<b>Product / Process Change Notification (PCN)</b>	
<input checked="" type="checkbox"/> Major Change <input type="checkbox"/> Minor Change	
<p><b>PCN Number:</b> PCN_FeFlat_20241220</p> <p><b>Affected Series:</b> WE-FLAT</p> <p><b>Affected Order Codes:</b> See table below</p> <p><b>PCN Date:</b> 2024-09-20 (YYYY-MM-DD)</p> <p><b>Effective Date:</b> 2024-12-20 (YYYY-MM-DD)</p>	<p><b>Change Category:</b></p> <p><input type="checkbox"/> Equipment/Location</p> <p><input checked="" type="checkbox"/> General Data</p> <p><input type="checkbox"/> Material</p> <p><input type="checkbox"/> Process</p> <p><input type="checkbox"/> Product Design</p> <p><input type="checkbox"/> Shipping/Packaging</p> <p><input type="checkbox"/> Supplier</p> <p><input type="checkbox"/> Software</p>
<p><b>Contact:</b> Product Management</p> <p><b>Phone:</b> +49 (0) 7942 - 945 5001</p> <p><b>Fax:</b> +49 (0) 7942 - 945 5179</p> <p><b>E-Mail:</b> pcn.eisos@we-online.com</p>	<p><b>Datasheet Change:</b></p> <p><input checked="" type="checkbox"/> Yes      <input type="checkbox"/> No</p> <p><b>Attachment:</b></p> <p><input type="checkbox"/> Yes      <input checked="" type="checkbox"/> No</p>

<p><b>Description of Change

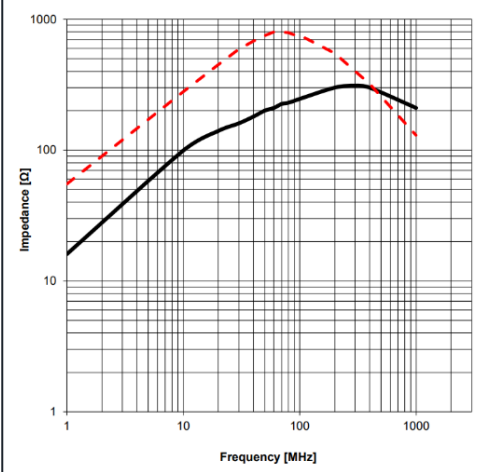
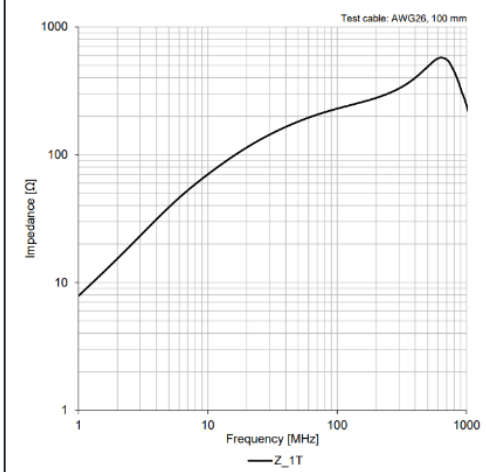
3. The visualization of chart for the **“Typical Impedance Characteristics”** changes. The used type of cable and cable length is shown in each chart.

<p><b>BEFORE CHANGE:</b></p> <ul style="list-style-type: none"> <li>Showing only one graph with 1 turn (1T) and 2 turns (2T) impedance curves.</li> </ul> 	<p><b>AFTER CHANGE:</b></p> <ul style="list-style-type: none"> <li>Showing a graph for the 1 turn (Z_1T) impedance curve with the shortest possible cable length according to the product.</li> </ul> 
<ul style="list-style-type: none"> <li>Showing no graph with 3 turns impedance curve.</li> </ul>	<ul style="list-style-type: none"> <li>Showing a graph for 1-3 turns (Z_1T, Z_2T, Z_3T) impedance curves with the shortest possible cable length, which is required for 3 turns according to the product.</li> </ul>
